Application for Works Approval

Works Approval Number W6513/2021/1

Premises Midland Pumping Station No. 51-10
500 Katharine Street
BELLEVUE WA 6056

Date of Report 6 September 2021

Figure 1: Estimated public open space emergency overflow footprint (green shading) inferred from the 12.75 m elevation contour adjacent the SPS premises (red shading).

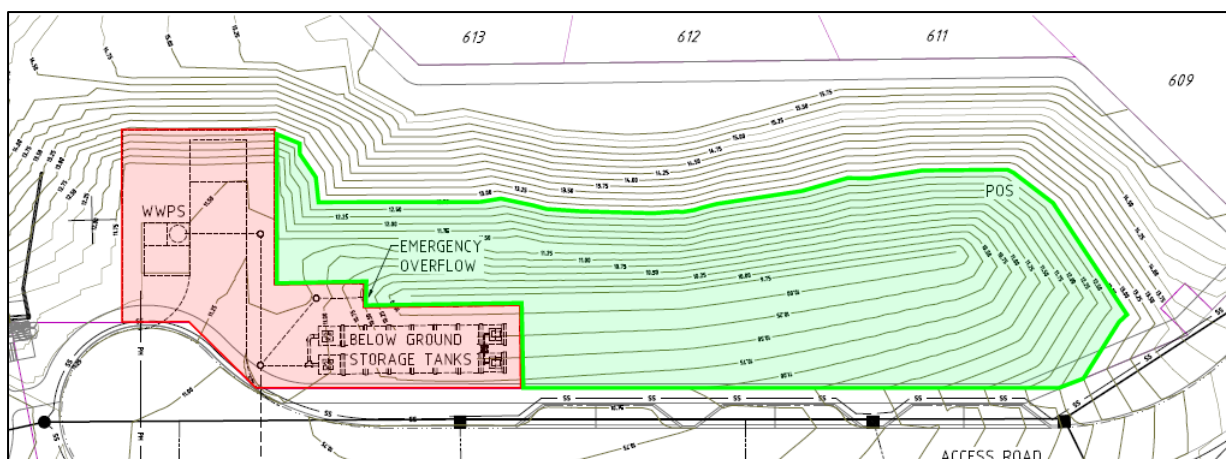
| Storage location | Storage capacity (volume) | Storage capacity (time) |
|--|---|-------------------------|
| Outside of premises: Public open space located north to north west of the SPS as depicted in | Not defined (Note: Department assumes volume is approximately 270.6 m ³ based on values above). | 9 hours |

- vi) In the event that vacuum tankers cannot keep pace with an overflow, sewage will then discharge into an enclosed public open space swale adjacent to the premises. The public open space swale will be topsoil over the natural clay and there will be no physical connection to the living streams.

Key Finding: The Delegated Officer considers that a discharge of untreated sewage to public open space could result in public health impacts from primary and/ or secondary contact.

- vii) Vacuum tankers will be deployed to recover sewage from the public open space swale. Access by the public will be restricted and disinfectant will be applied.
